RE: Hydrogen Energy California Project  
Application for Certification 08-AFC-8

**Amendment to the  
Revised  
Application for Certification  
(08-AFC-8)  
for  
HYDROGEN ENERGY CALIFORNIA  
Kern County, California**

September 2009

PRELIMINARY  
HAZARDOUS MATERIAL LOCATION PLAN  
September 2009 Hydrogen Energy California (HECA)  
28067571 Kern County, California  
URS  
REVISED FIGURE 2-35

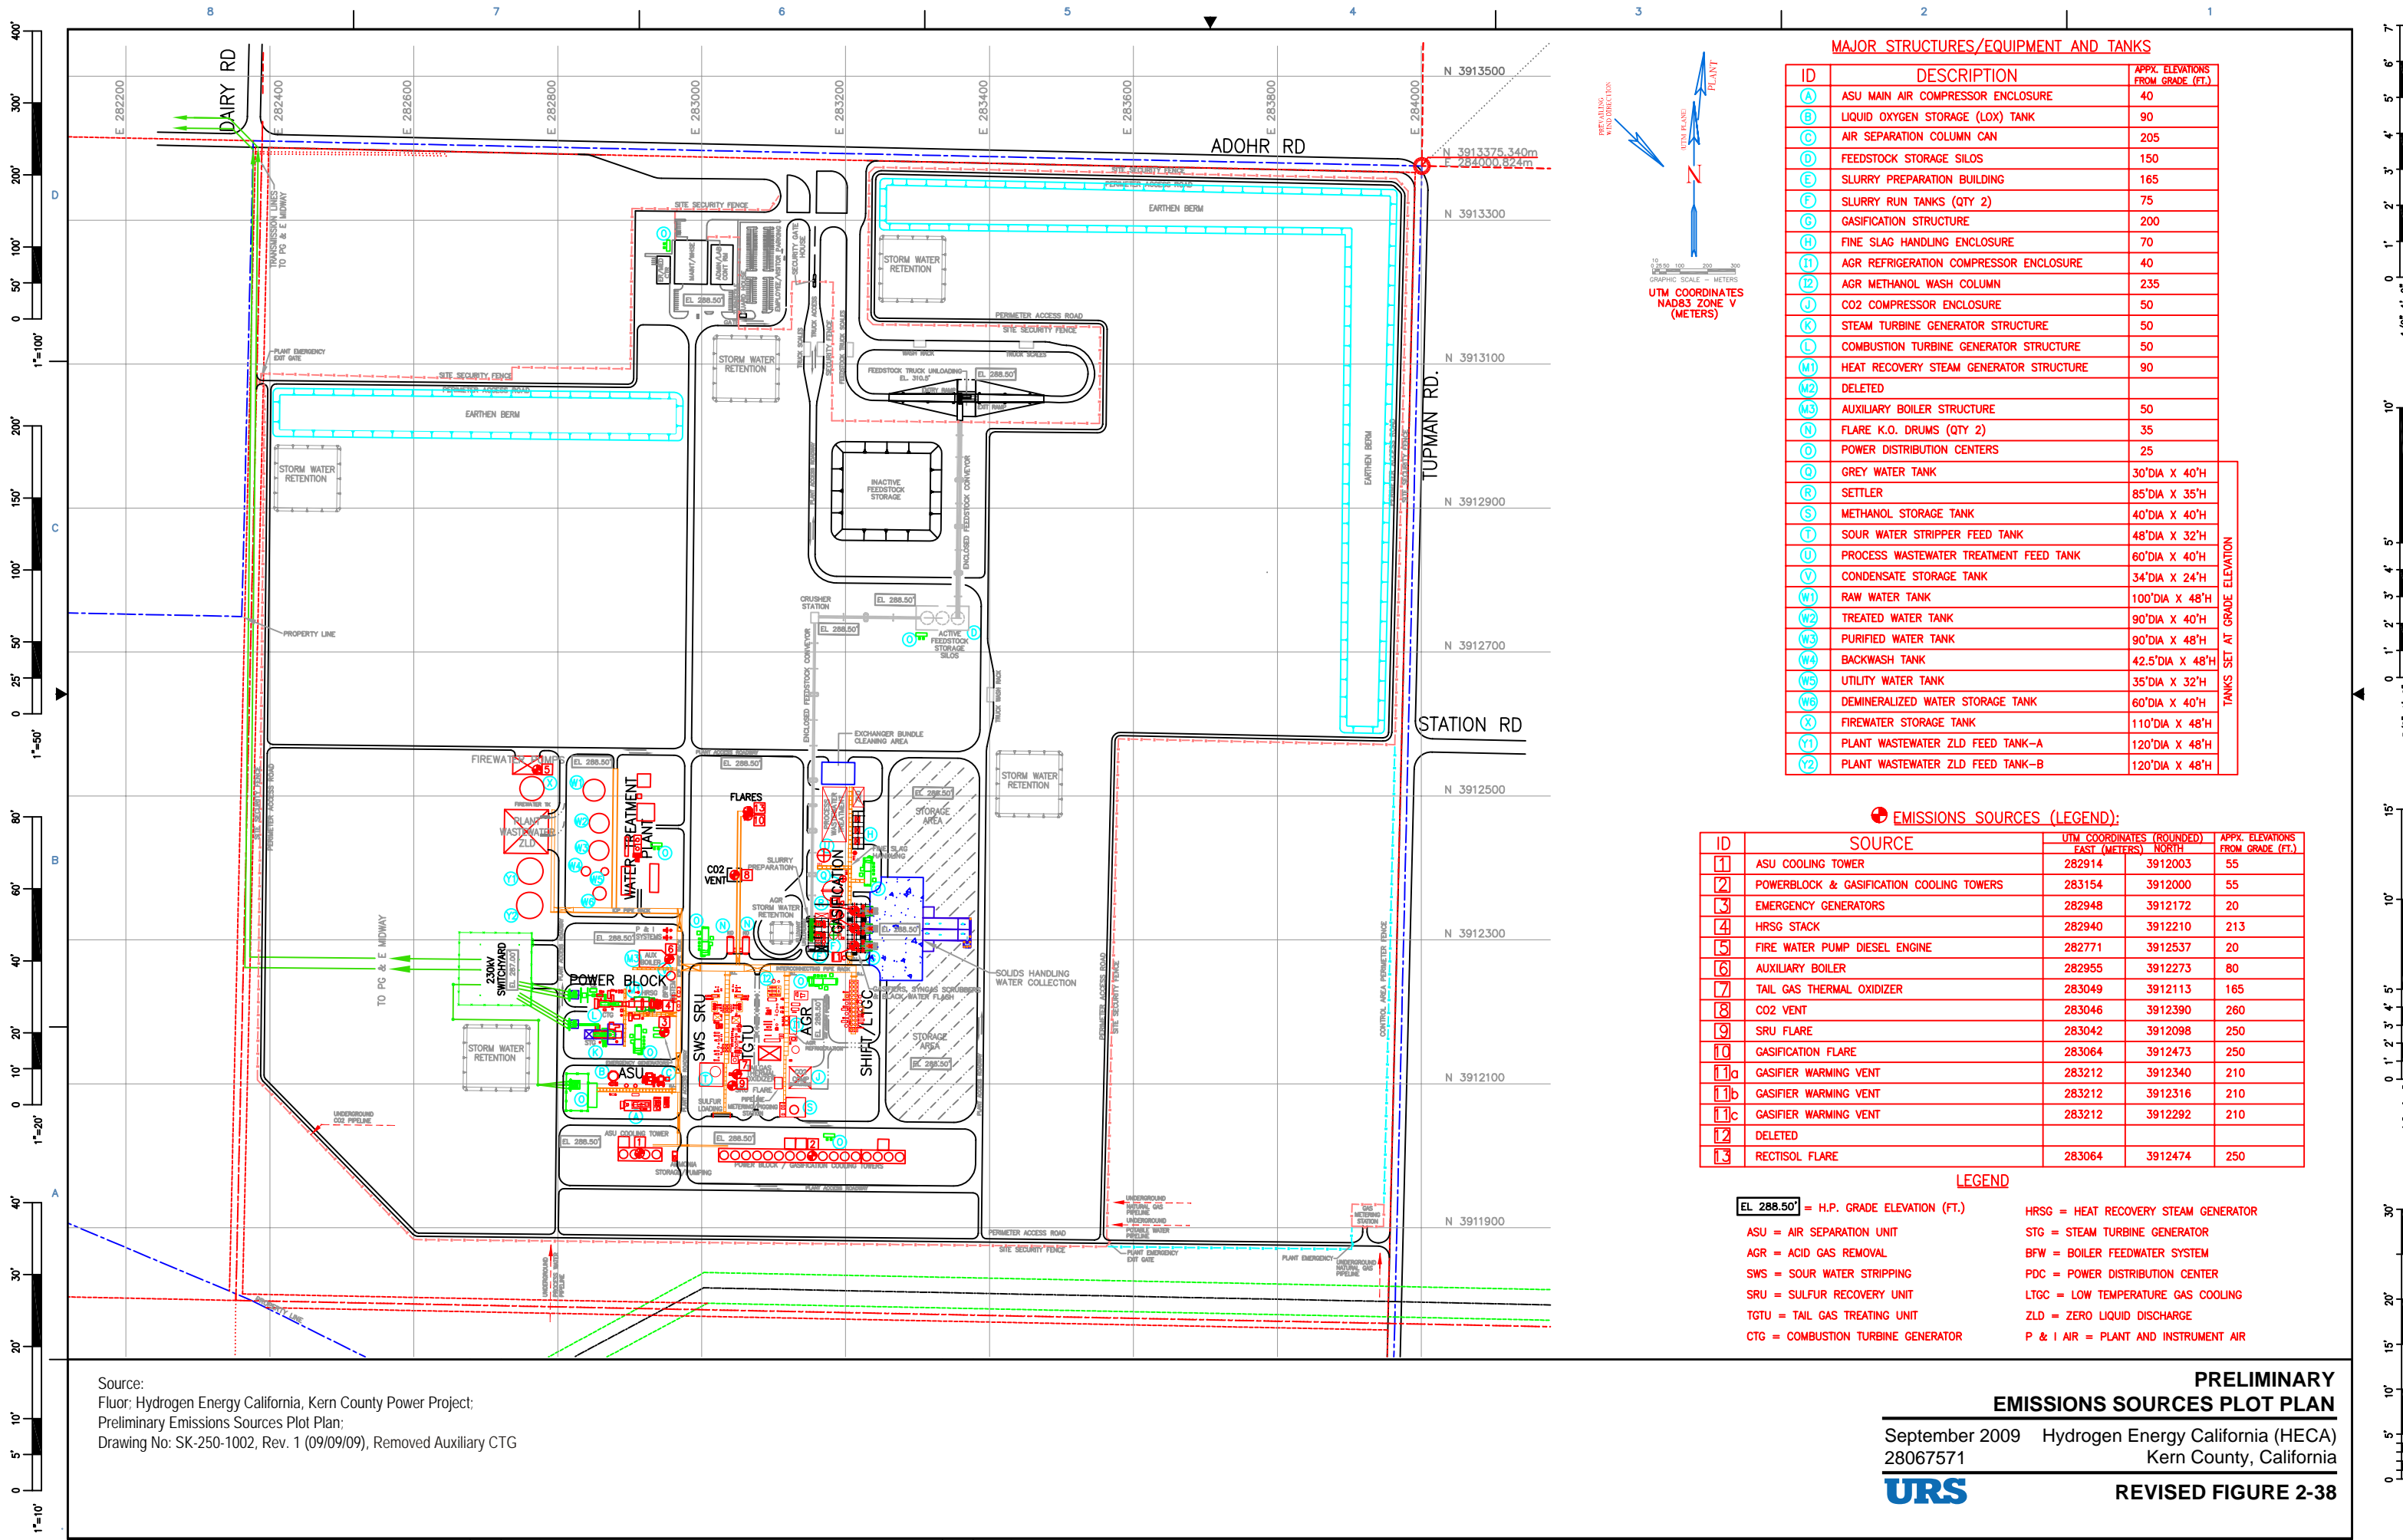
Revised Figure 2-35, Preliminary Hazardous Material Location Plan, is included in this Revised AFC Amendment. The only change in this figure is the deletion of the auxiliary CTG. The hazardous material locations are unchanged from the original figure.

Source:  
Fluor; Hydrogen Energy California, Kern County Power Project;  
Preliminary Hazardous Material Location Plan;  
Drawing No: SK-250-1003, Rev. 1 (09/09/09), Removed Auxiliary CTG

**PRELIMINARY**  
**EMISSIONS SOURCES PLOT PLAN**  
September 2009 Hydrogen Energy California (HECA)  
28067571 Kern County, California  
**URS**  
**REVISED FIGURE 2-38**

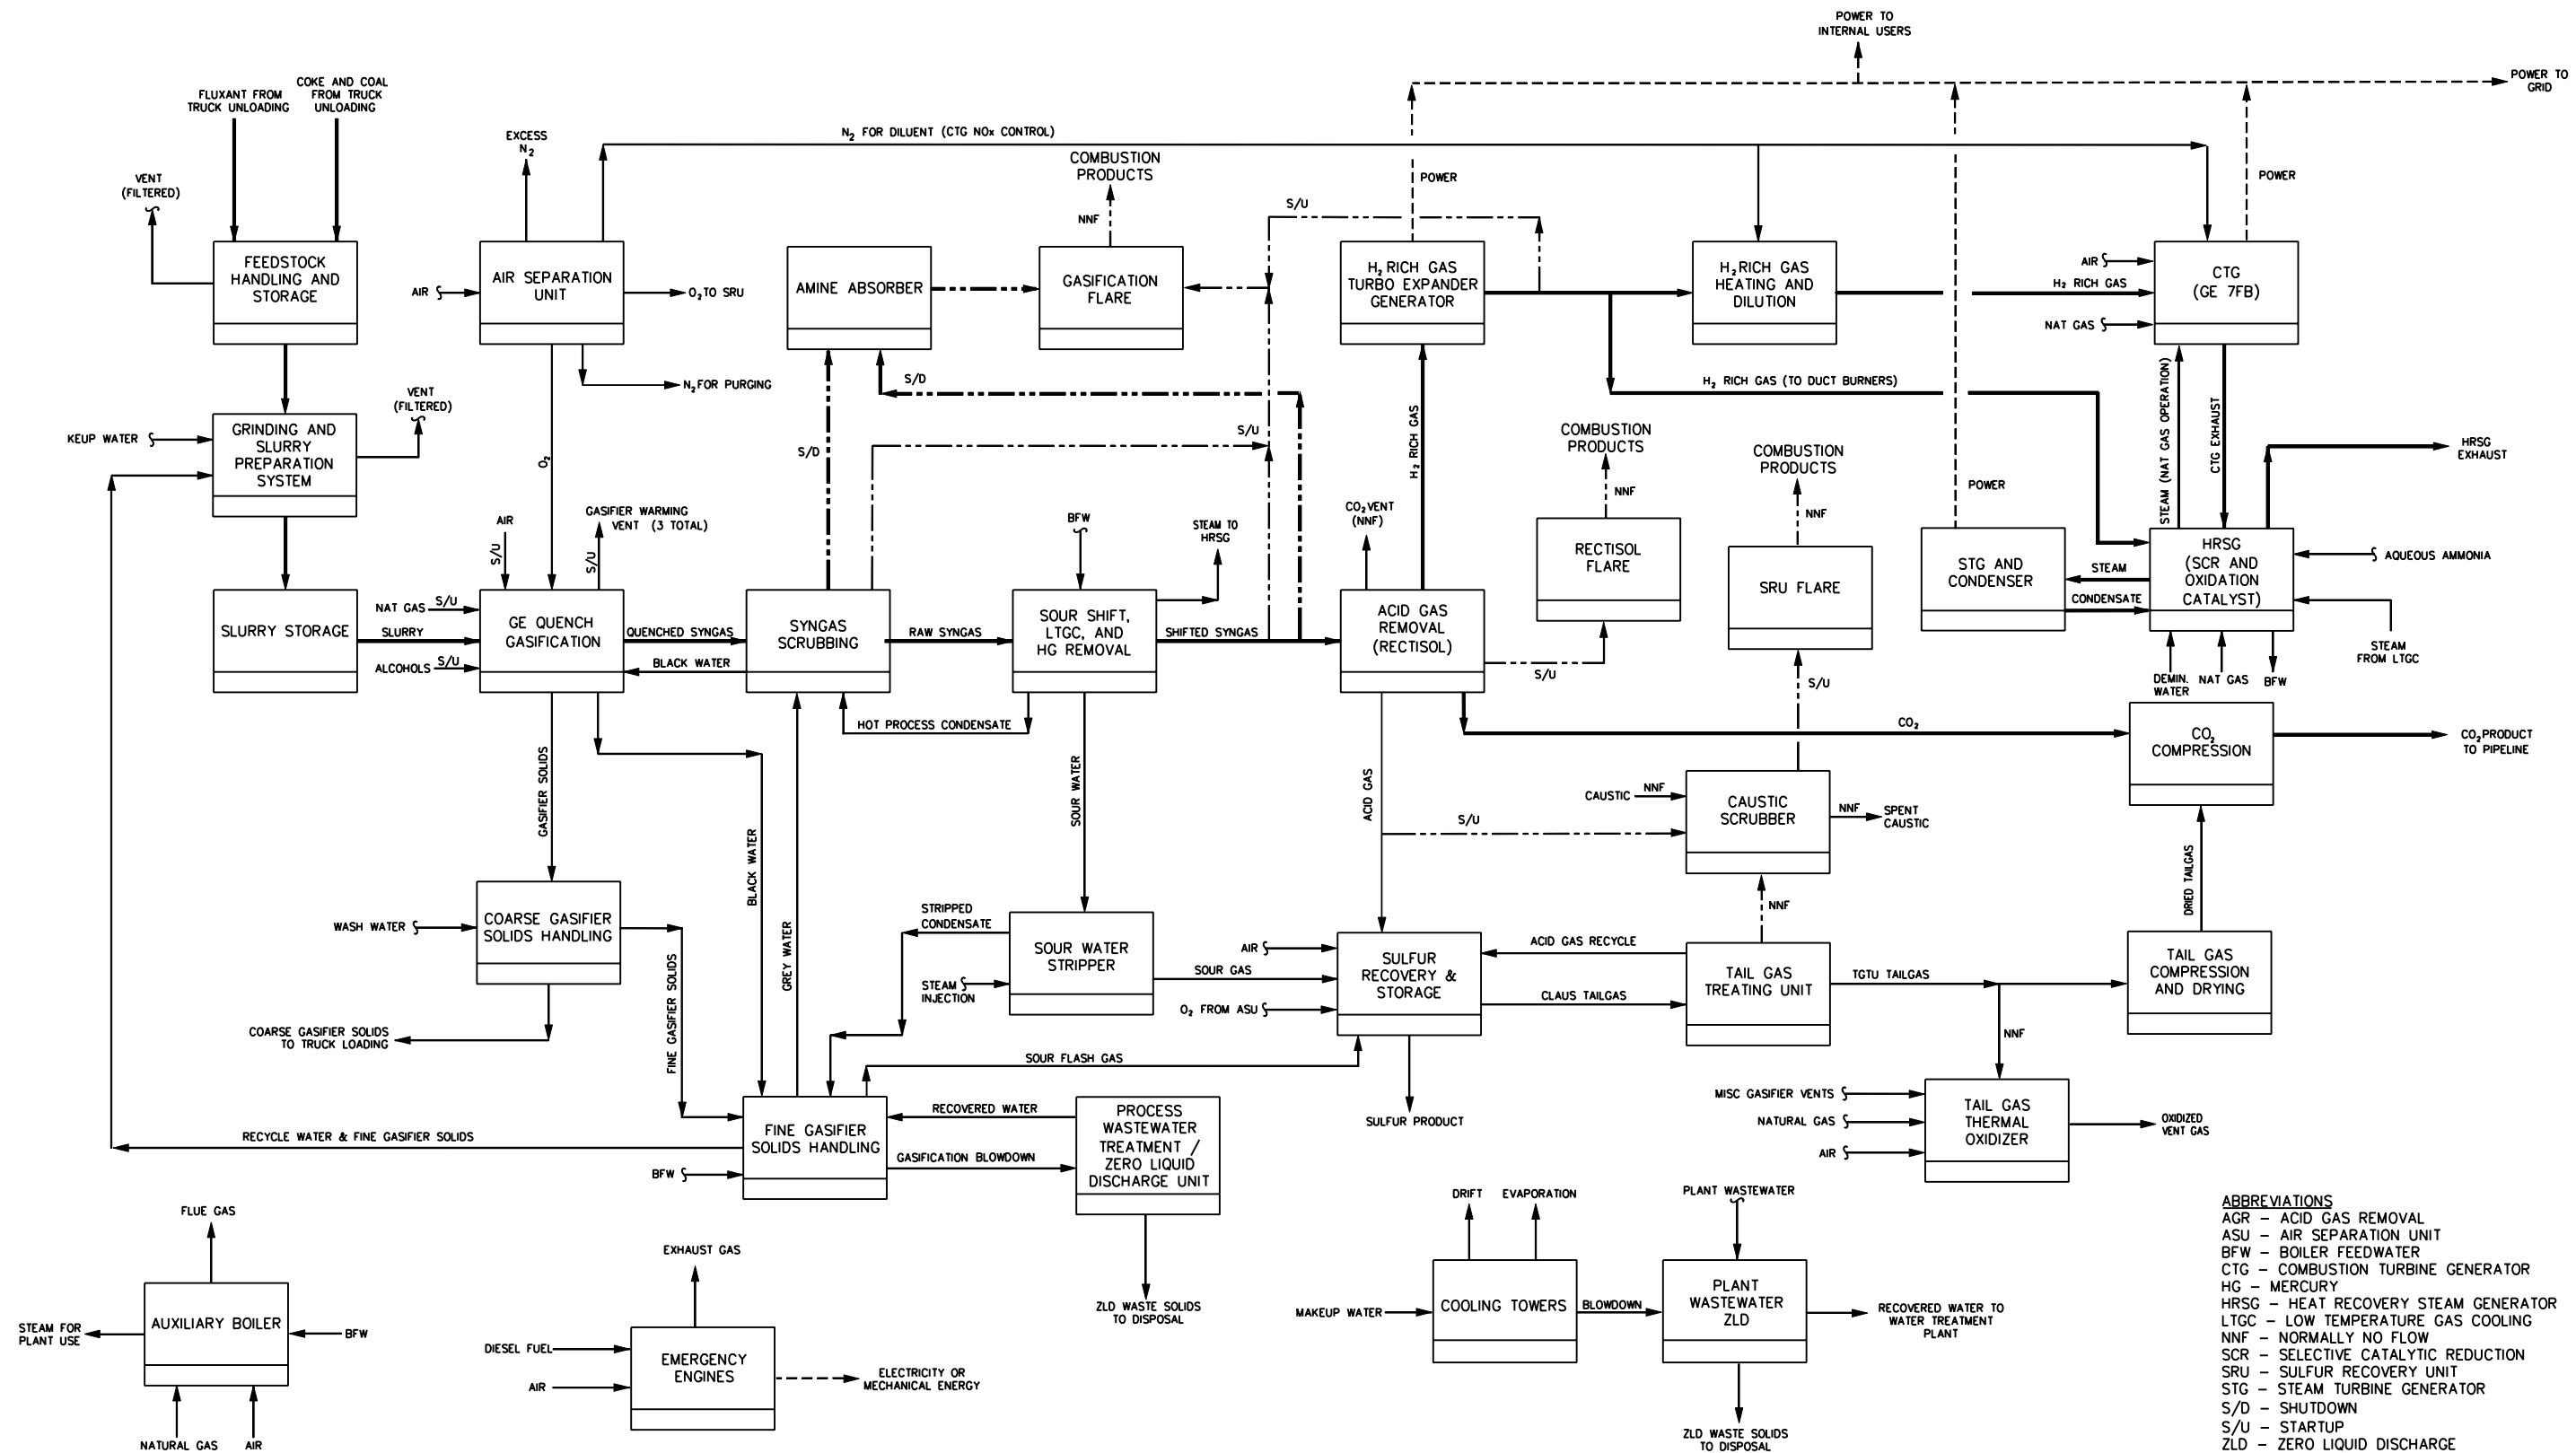
Changes to the above figures includes removal of equipment shown as Auxiliary CTG Structure and Auxiliary CTG Stack (identified as M2 and 12, respectively, on Figures 2-6 and 2-38) of the Revised AFC.

Source:  
Fluor: Hydrogen Energy California, Kern County Power Project;  
Preliminary Emissions Sources Plot Plan;  
Drawing No: SK-250-1002, Rev. 1 (09/09/09), Removed Auxiliary CTG

**REVISED FIGURE 2-39**

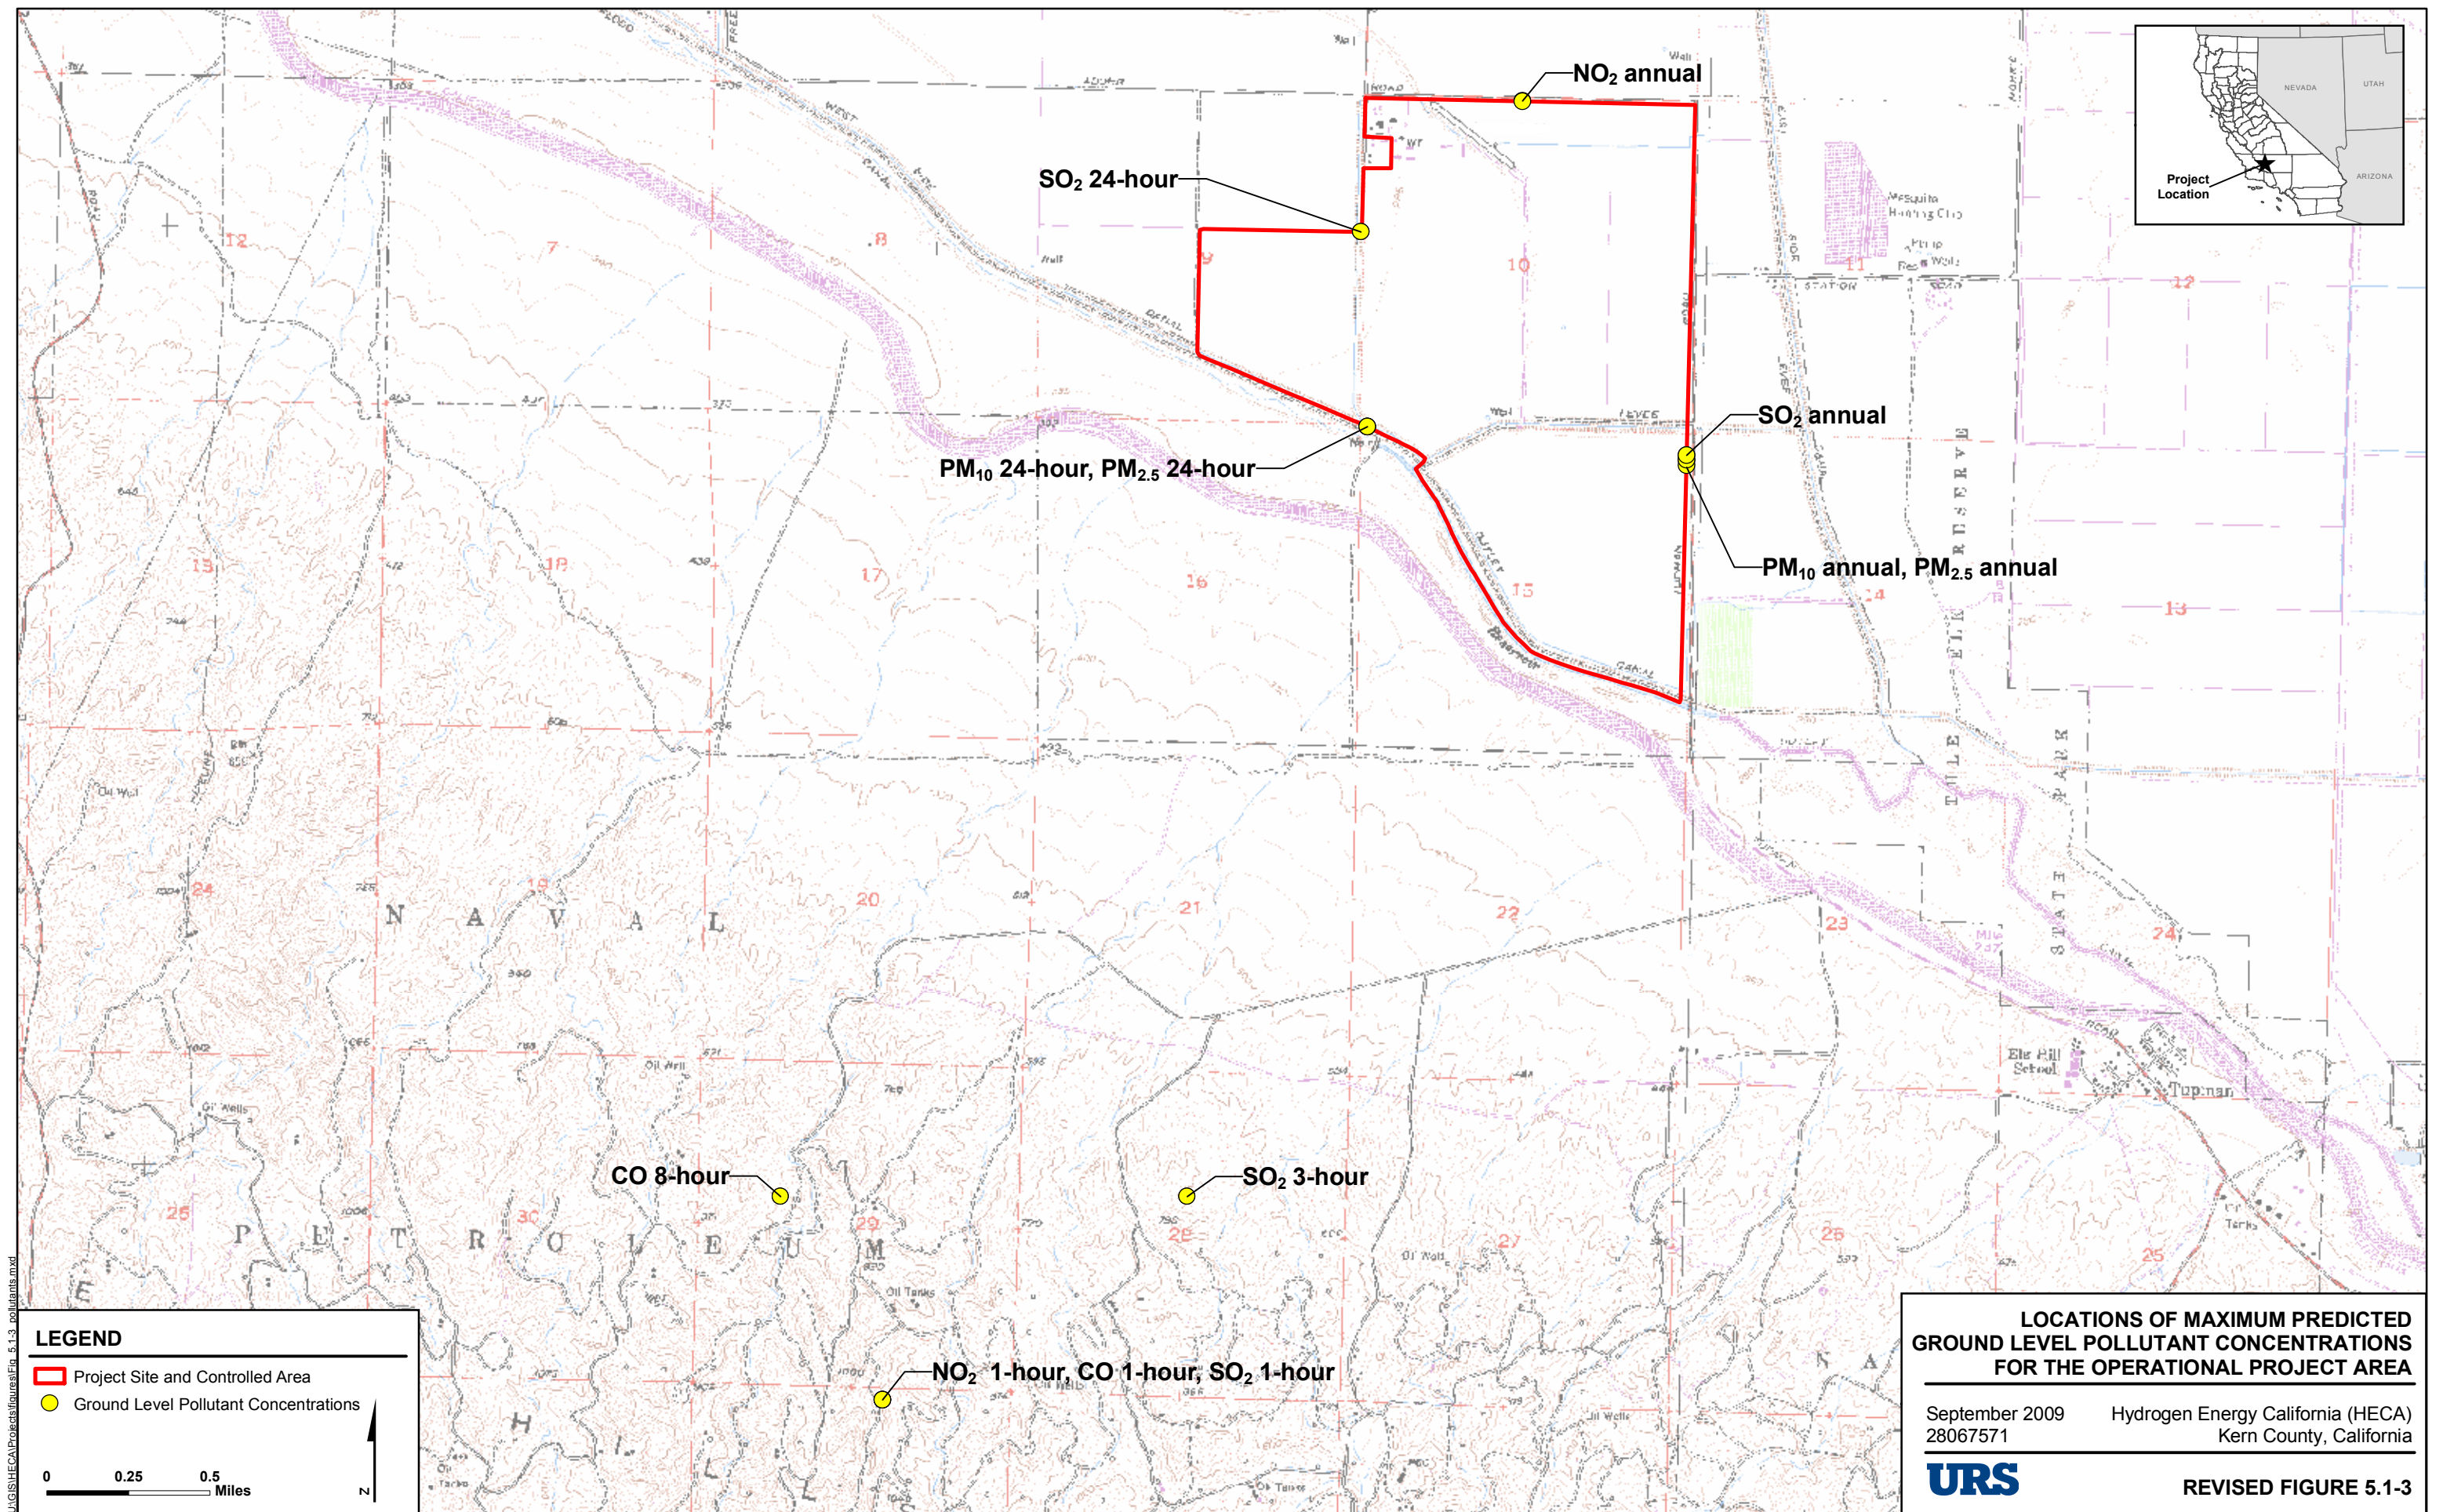
Source:  
 Fluor; Hydrogen Energy California, Kern County Power Project;  
 Block Flow Diagram with Air Emission Sources;  
 Drawing No: A3RW-BFD-25-023, Rev. 3 (09/03/09), Removed Auxiliary CTG
